Subject: RE: [External] Re: [External] 33 Maplewood Road Septic Sketch

Attached are the soils information and preliminary calculations for a replacement septic system at 33 Maplewood Road in the Town of Ulysses.

Project No. 25-22 33 Maplewood Road SOIL INVESTIGATION - DEEP TEST HOLES

SYSTEM SIZING CALCULATIONS (PER NYSDOH APPENDIX 75-A)

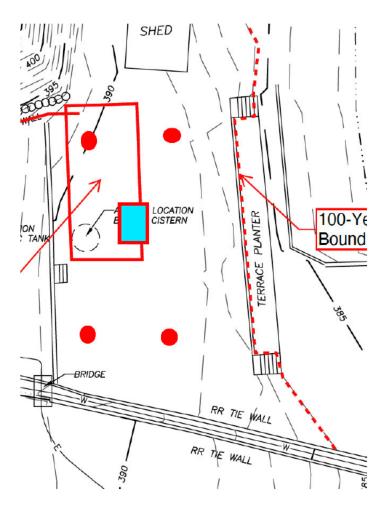
Where were the DH and PTs taken? I am sorry if I missed this.

That seems like are reasonable design with the ETU. Thanks for checking.

Sorry - I should have added them to the sketch. The DTH is the blue rectangle and the PT's are the red dots below.
